KENAITZE INDIAN TRIBE

Transportation Building and Covered Parking Design-Build Request for Proposal

Questions and Answers

Issued: November 29, 2022

A GRADING PLAN

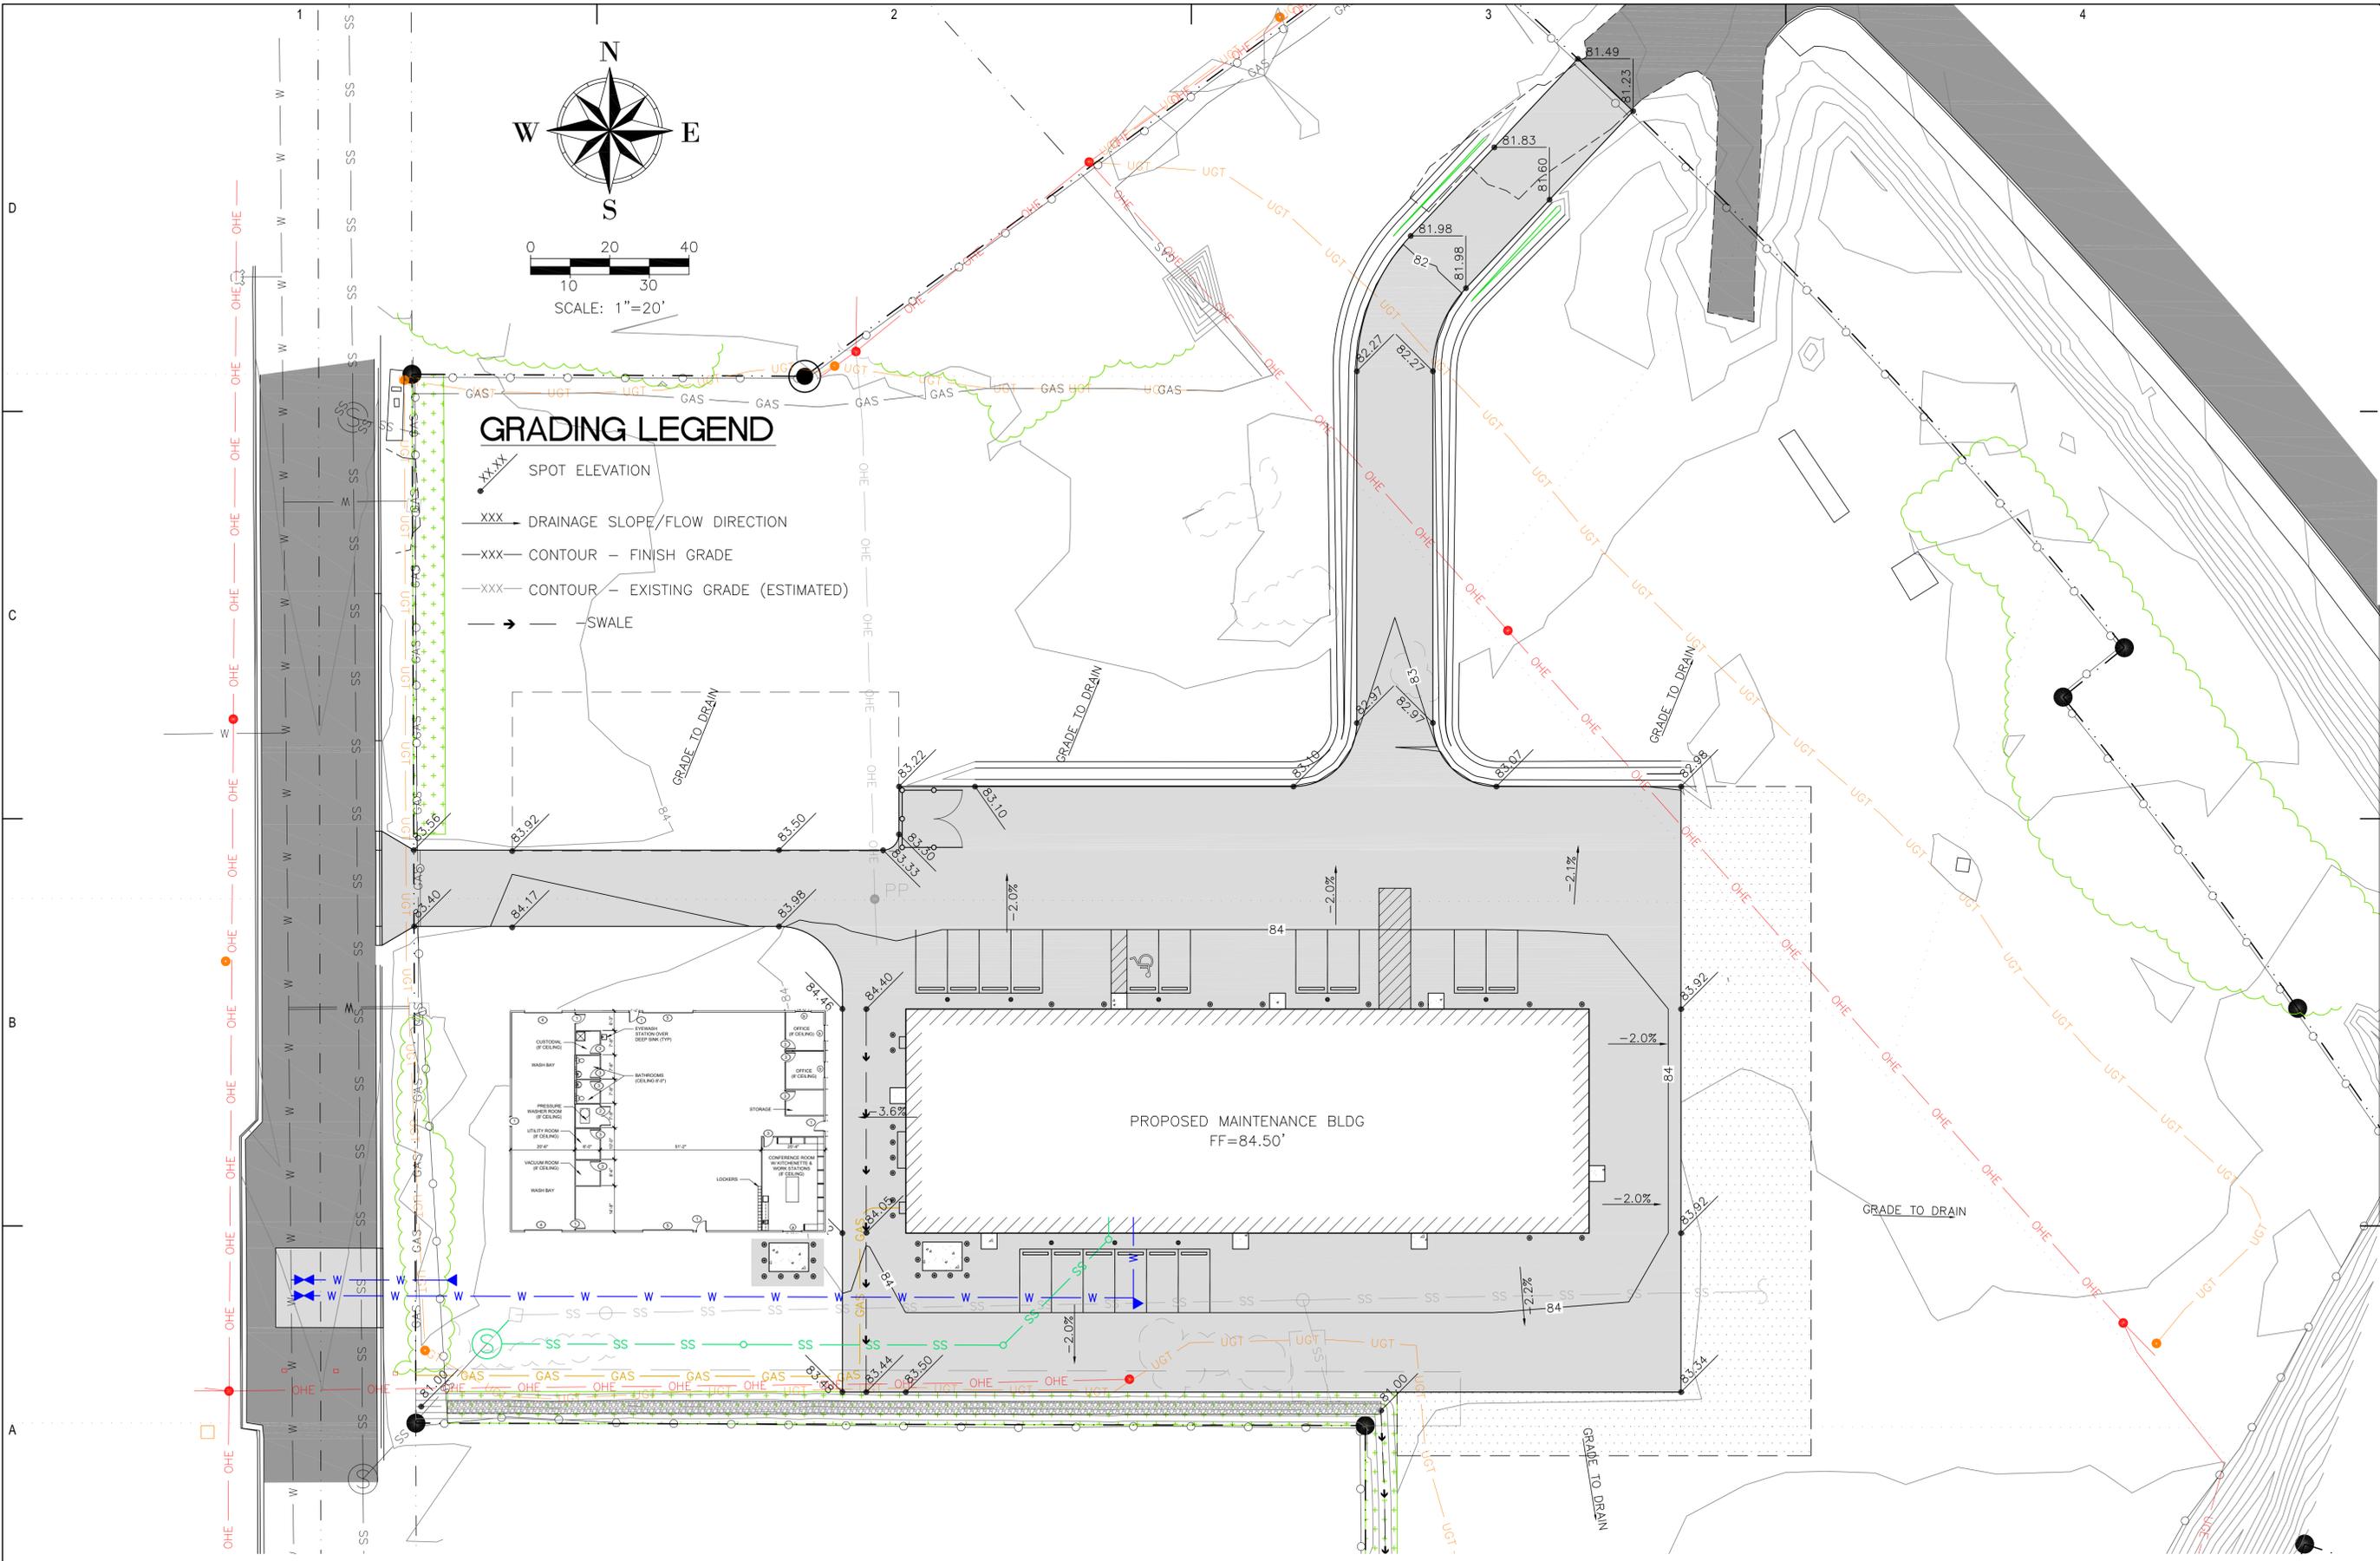
6. Is there a specific orientation that Kenaitze wants the buildings oriented on site or is that up to the bidder to propose? **See attached Drawing**
7. It is assumed water and waste will use the city of Kenai utilities? There is no site plan in the design package. **City water and sewer connection points are onsite, ENSTAR is onsite (DB will provide building load calculations to ENSTAR and coordinate meter location), HEA is overhead (DB will provide building load calculations to HEA for new transformer & pad and coordinate placement and connection) . See attached Drawing. Gas meter and new transformer costs need to be accounted for in overall DB budget.**

13. RFP Section 5.1 calls out Objectives for Construction. Section "i" notes coordination with HEA, Enstar for pre-con information. Does the Tribe have any as-built information regarding locations of the Water/Sewer, HEA & Enstar existing infrastructure at the site? **See attached building placement and site utility Drawings**
